L-23/2007

Subject: RE: Questionable residential lot....

14406 OAKWOOD PL NE this address appears to discharge onto the neighbors to the south. I feel we need a drainage plan. We have nothing of use on record.

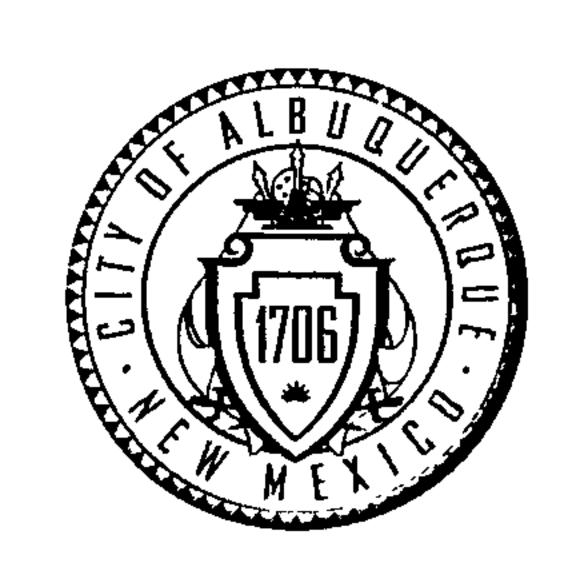
As discussed, do not approve the plan with comment "Describe to Hydrology how this addition can be constructed without adversely affecting your downstream neighbor."
